TOWN OF CHAPIN
Architectural Review Board Regular Meeting
Council Chambers, Chapin Town Hall
September 10, 2025
6:00 PM

To: Architectural Review Board
From: R. Radtke, Planning & Zoning Manager
Date: August 21, 2025
Re: Collo Rosso Dermatology

To: Architectural Review Board
From: R. Radtke, Planning & Zoning Manager
Date: August 22, 2025
Re: Outparcel 3– **Medical Office- MUSC**

DRAWN BY:	AKS
CHECKED BY:	AKS
APPROVED BY:	RDS
DATE:	MAY 16, 2025
SCALE:	1" = 20'
JOB No.	2024-0249
DRAWING No.	C300

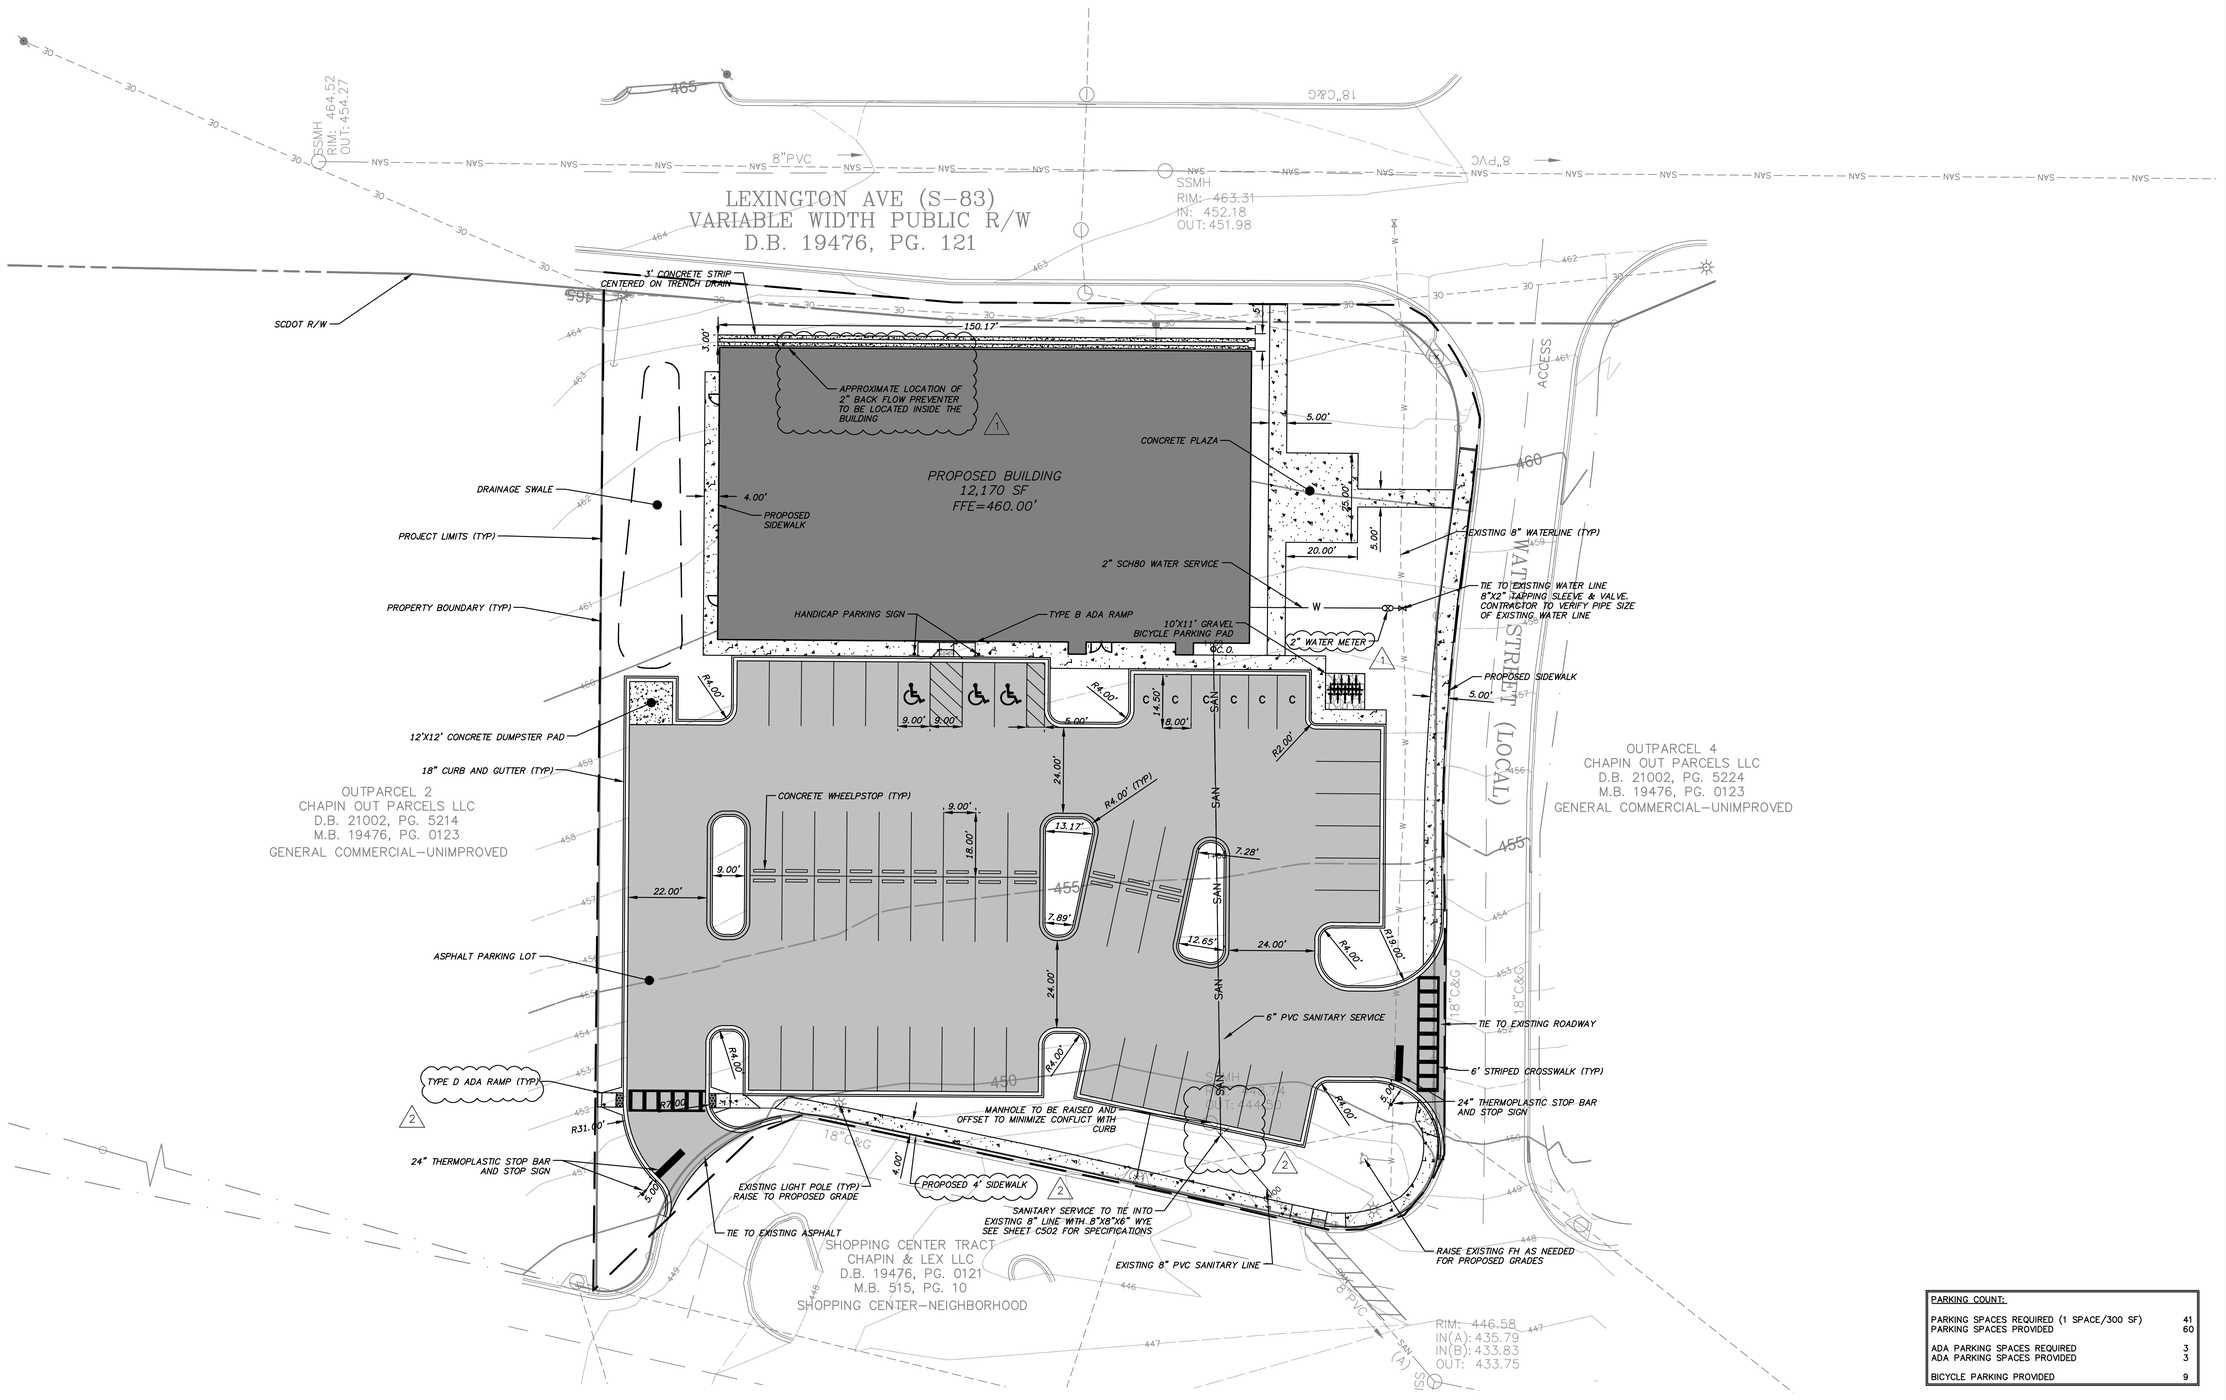
4. ARB requested to extend pedestrian sidewalk along Mavis side with crosswalk connecting. Foot candles on sidewalks mounting height. (Updated changes. In compliance). Pedestrian sidewalk now extends from adjacent property, east through the bottom of our site, and north to Lexington Ave. sheet C300. See photometric for heights. 24' from Gnd.

sheet C300. We are currently working with our Civil Engineer to provide an impact analysis of adding an ADA Ramp and crosswalk to Mavis' Outparcel.

DRAWN BY:	SRN
CHECKED BY:	LNA
APPROVED BY:	LFC
DATE:	05/16/2025
SCALE:	1" = 20'
JOB No.	2024-0249
DRAWING No.	L101

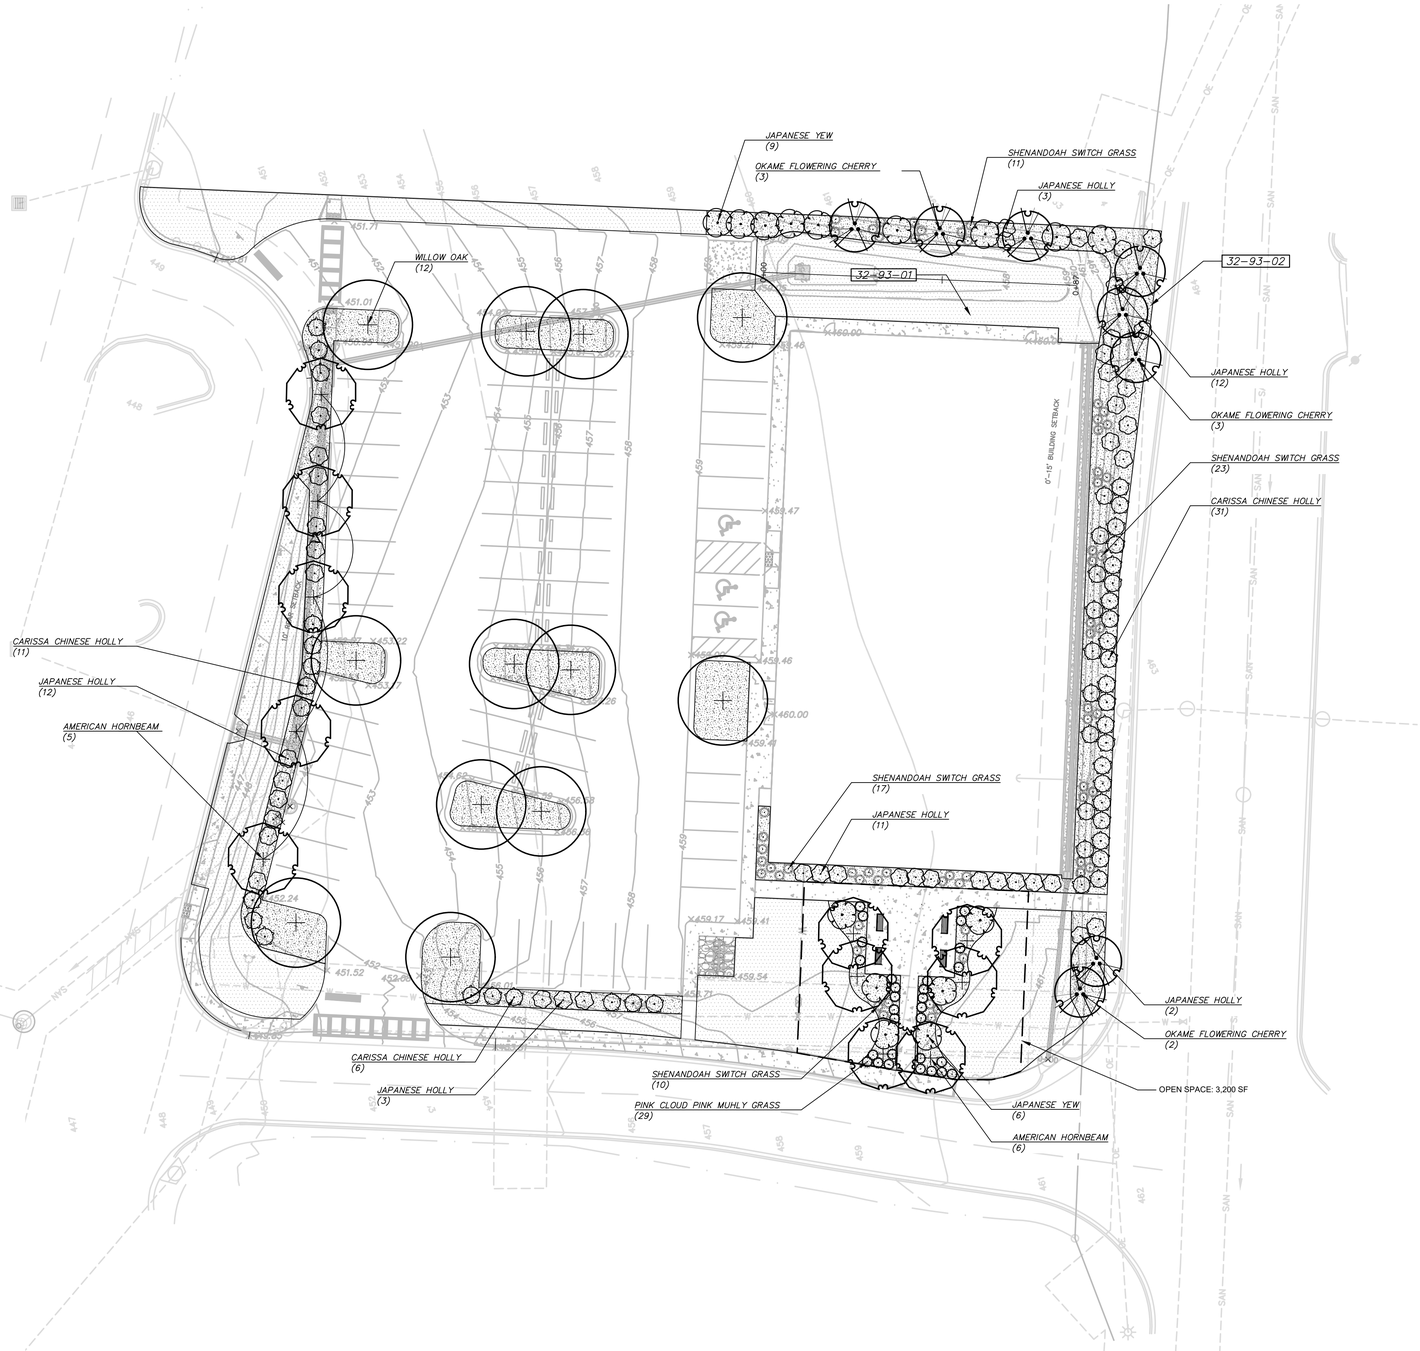
- Landscape front drainage to match side landscaping and dumpster area.

- Landscape around retention pond or open space.
    - This has been corrected for the plan north side of the property, please see the attached sheet L101.

5. Update w/ details (In Compliance) on plans for open space 5%. Sheet L101 outlining our 3,200 SF
6. ARB requested Landscape around retention pond or open space. In Compliance**.** MOB made the changes and corrected for the plan north side of the property, sheet L101**.**

- This has been corrected for the plan north side of the property, please see the attached sheet L101.

SHEET:
A-501

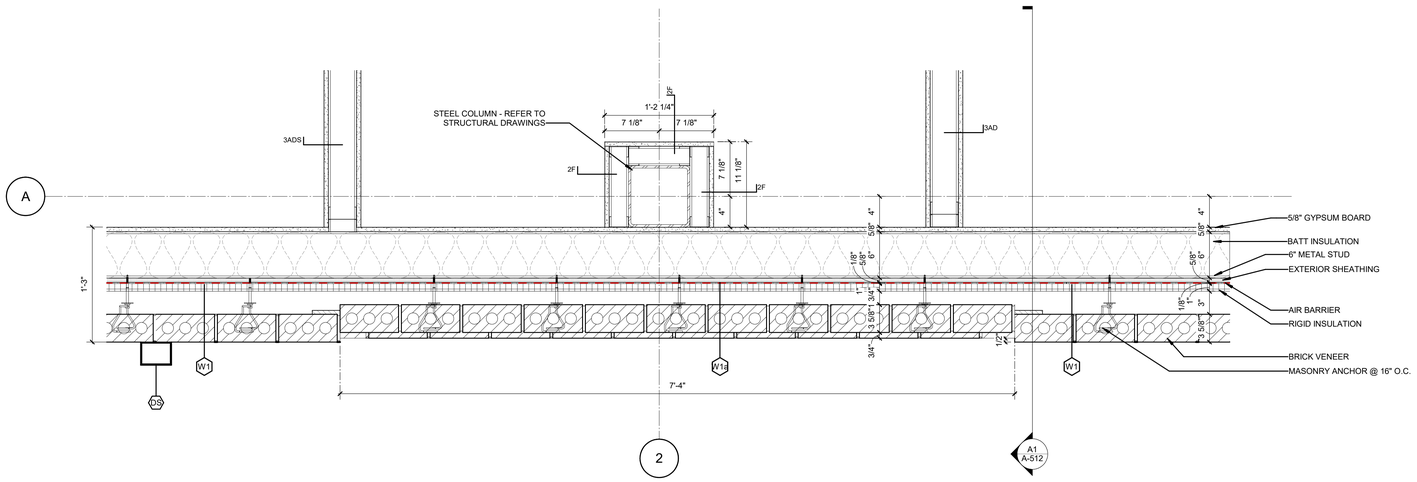
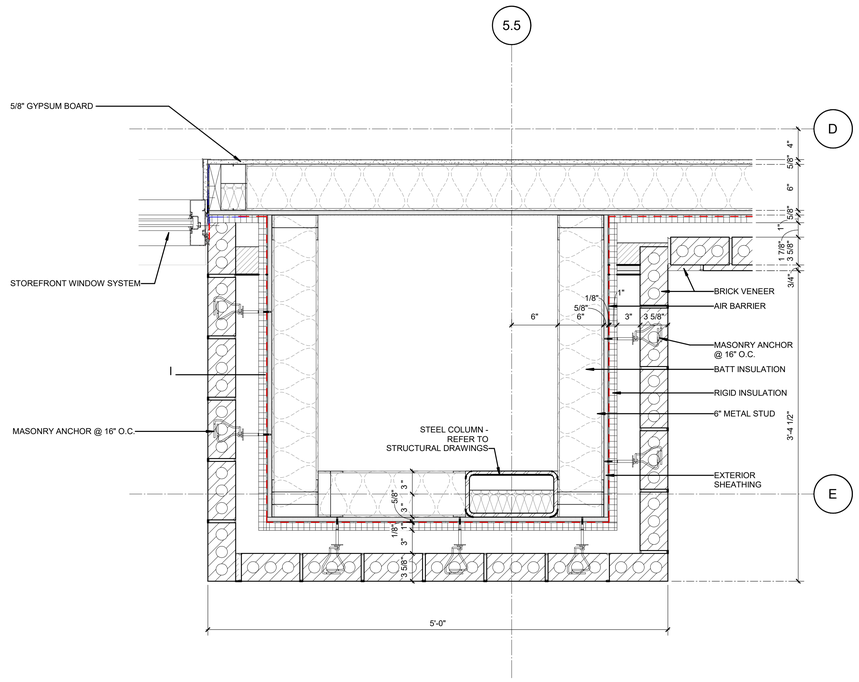
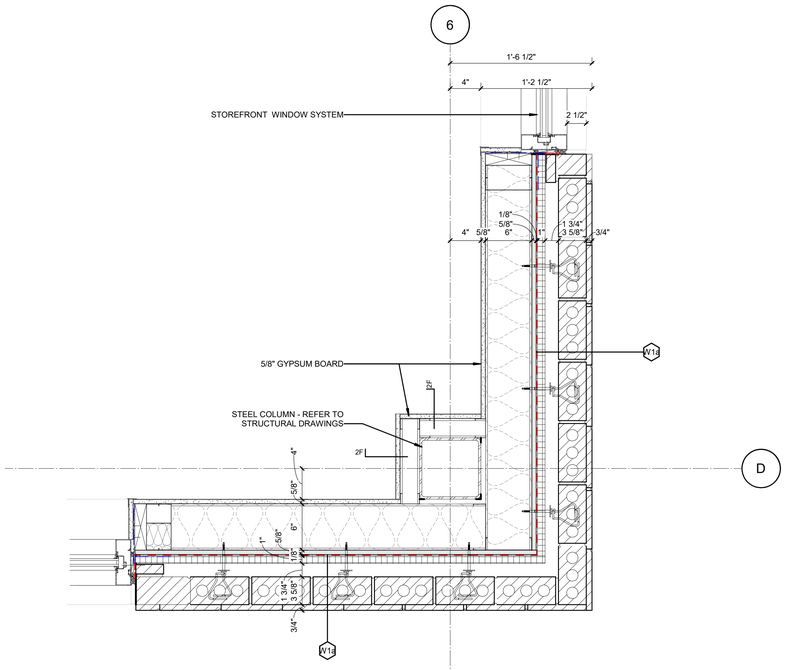
The ARB then reviewed the information with the updated renderings and indicated they would need to see more concise drawings of the columns to confirm bump out depths, glass metal frames to match darker brick color, landscape front drainage to match side landscaping and dumpster area, confirmation of colors to be compliant with approved color palette, and a full lighting plan to include wall sconce cut sheets, photometrics, and updated materials to parking lot poles with confirmation on height to match the current development.

- Provide specs on open space with calculations
  - Please see the attached sheet L101 outlining our 3,200 SF of open space. Open Space Calculations are also provided on this sheet.
- Need depth information on building columns and brick samples – Clarifications on materials. ARB stated would need more concise drawings of the columns to confirm bump out depths.
  - Below is a 3D image and detailed view illustrating how depth is thoughtfully integrated into the exterior design. The brickwork subtly shifts along all four elevations, creating shadow lines and enhancing visual interest. Structural columns are fully concealed within the interior and are not expressed on the exterior. Please reference Sheet A-501 for further details.
  -

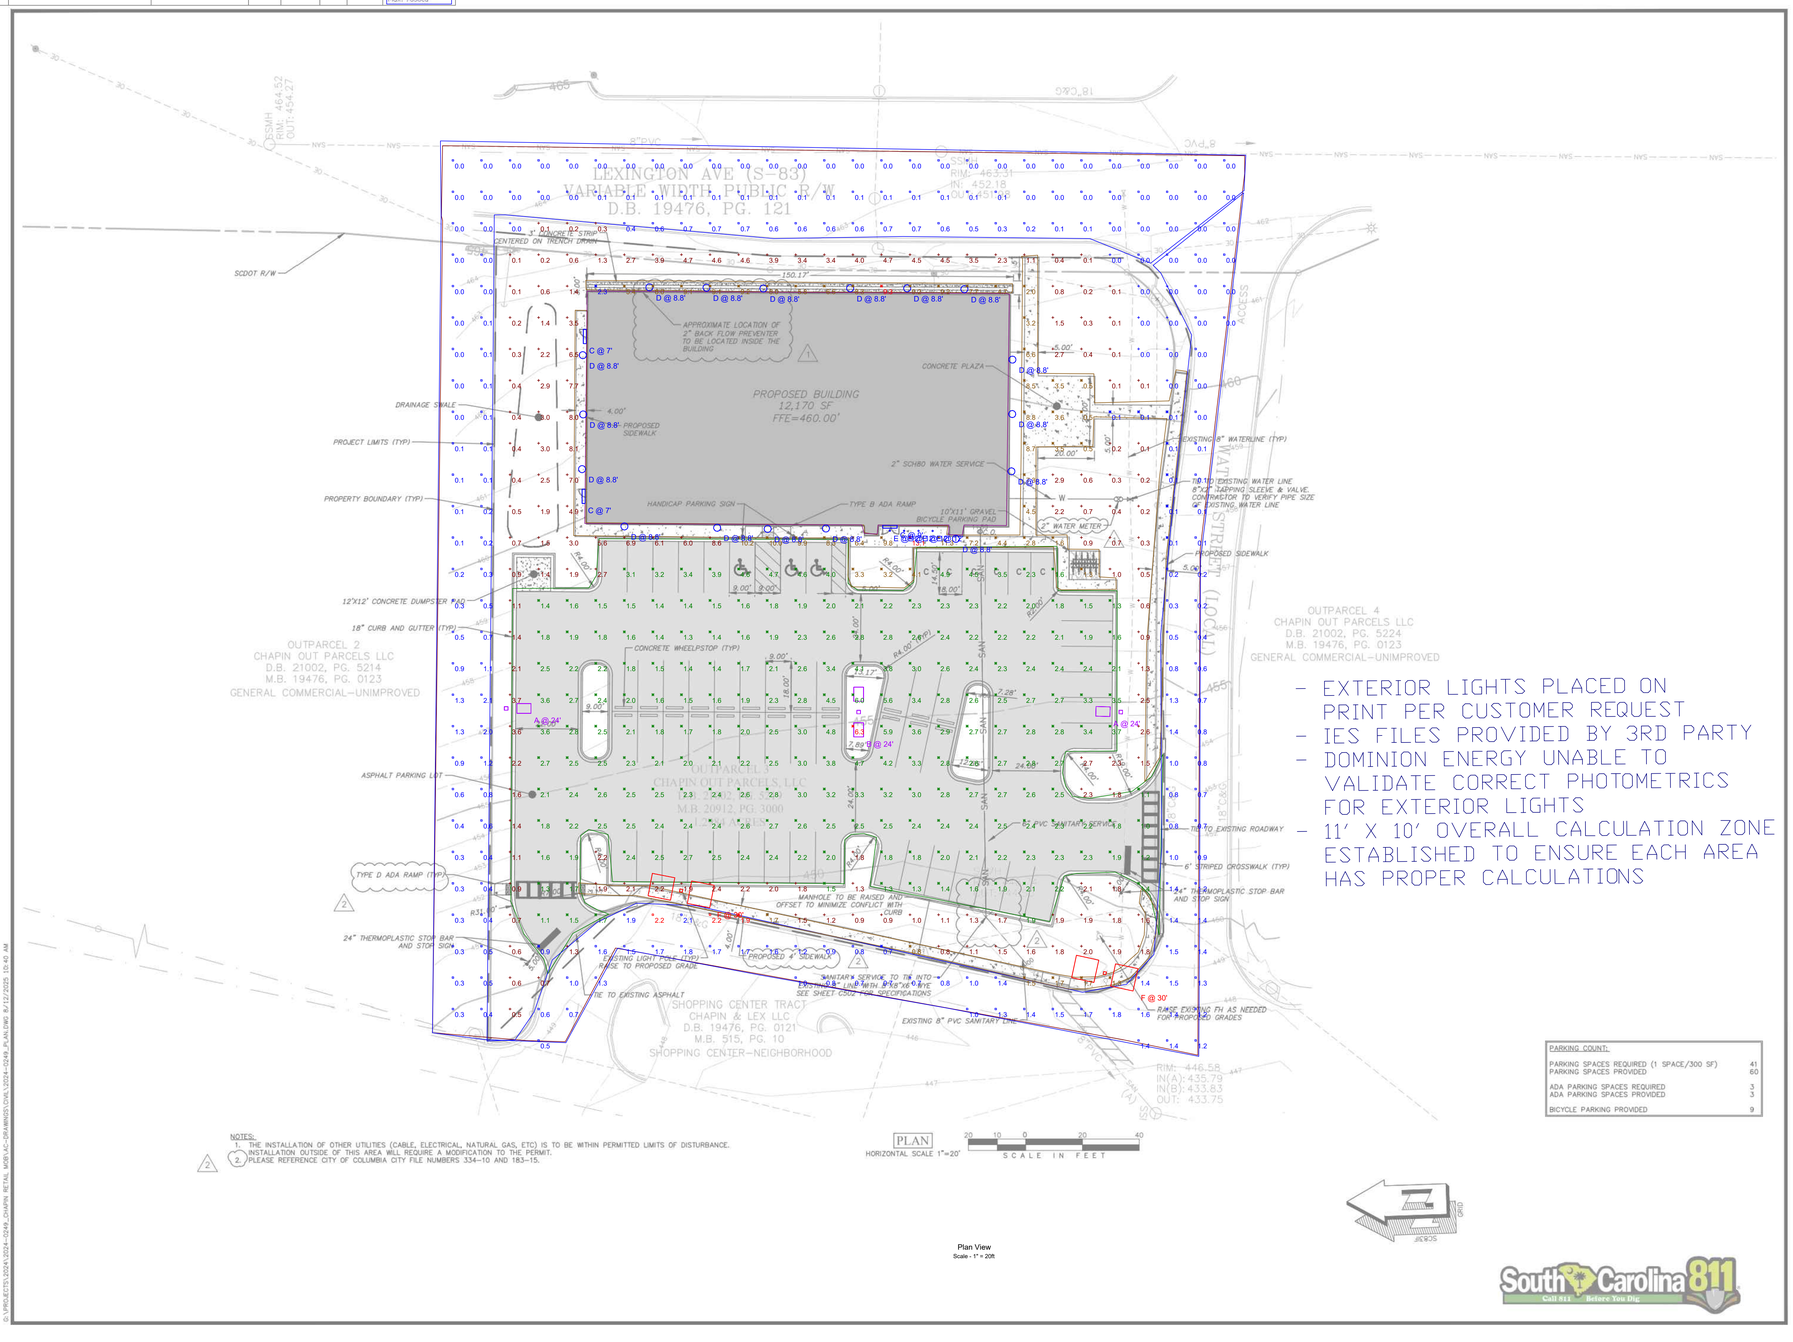
- Full lighting plan to include wall sconce cut sheets
    - Please see that attached Photometric Plan and associated cutsheets.
- Photometrics plan
    - Please see that attached Photometric Plan and associated cutsheets.

- Please reference the attached Photometric Plan for foot candles across the site.
  - Our mounting height is 24' from ground to top of pole for area lighting, please see the attached SCE&G Distribution Construction Standard cutsheet.
